#### Historic Preservation Board File No. 22-0524

### 1901 Collins Avenue Shore Club Petition for Rehearing

Presentation by Law Offices of Kent Harrison Robbins, P.A.

September 13, 2022

#### 20<sup>th</sup> STREET SINGLE LOADING AREA MANEUVERABILITY STUDY BASED ON SU-40 TRUCK

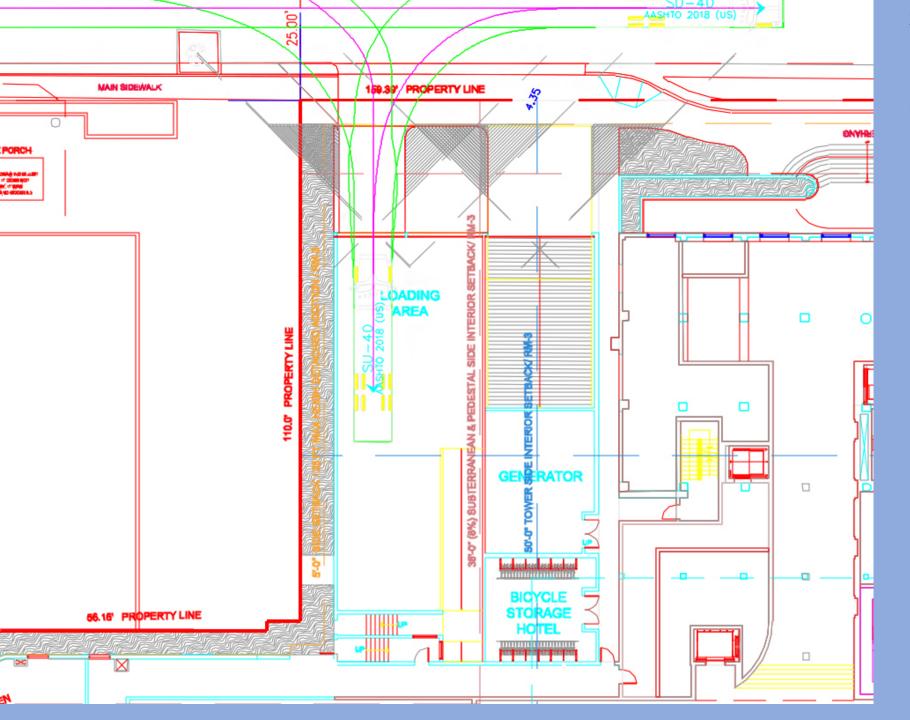
# A TOTAL OF THREE (3) LOADING SPACES ARE REQUIRED PURSUANT TO MIAMI BEACH CODE §130-101

A total of three (3) loadings spaces are required. §130-101, MBC.

(1) Size and location. For the purpose of these regulations a loading space is a space within the main building or on the same lot, logically and conveniently located for bulk pick-ups and deliveries, scaled to delivery vehicles expected to be used but not less than ten feet by 20 feet, and accessible to such vehicles when required off-street parking spaces are filled.

The HPB did not waive the deficiency in the off-street loading space requirement because there is no deficiency.

## NO PLAN APPROVED BY THE PARKING DEPARTMENT WAS PRESENTED

## THE BOARD DID NOT WAIVE THE REQUIRED OFF-STREET LOADING SPACES
